Initial Comments to
Ontario Society of Professional Engineers

Regarding
“Draft for Comment”

“Wind and the Electrical Grid”

Dated December 13, 2011

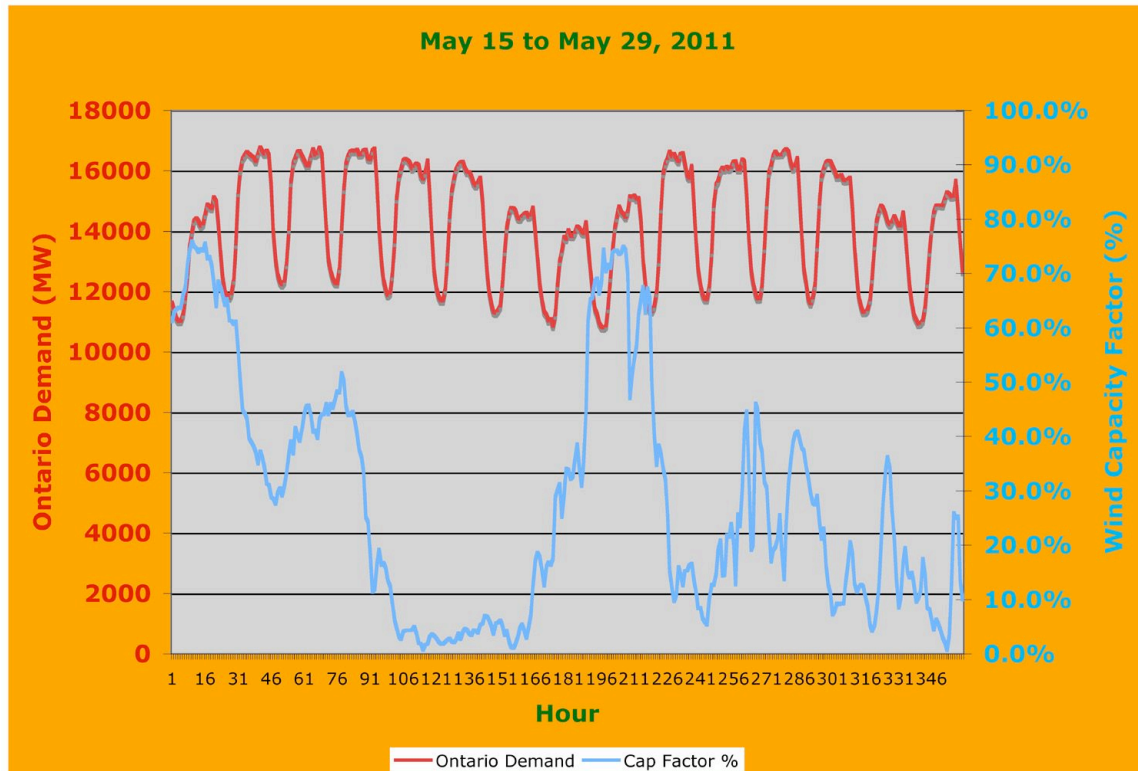
23,000 MW – potentially 9,000 MW of excess. As the OSPE report identifies, there is some maneuverability of the Bruce B reactors, where the backing off output from 800 MW to 550 MW occurs with considerable regularity. See the curves below.

Additionally, the OSPE report identifies that *“In the near future (likely by the spring of 2013) the shutdown of some of these base load generating facilities will be necessary to maintain electrical grid stability ...”* The OSPE draft is well behind time – the shutdown of Bruce Nuclear units has occurred already in the summer of 2010 and 2011 due to underutilized base load generation, at times when the wind generators were barely over 1000 MW.
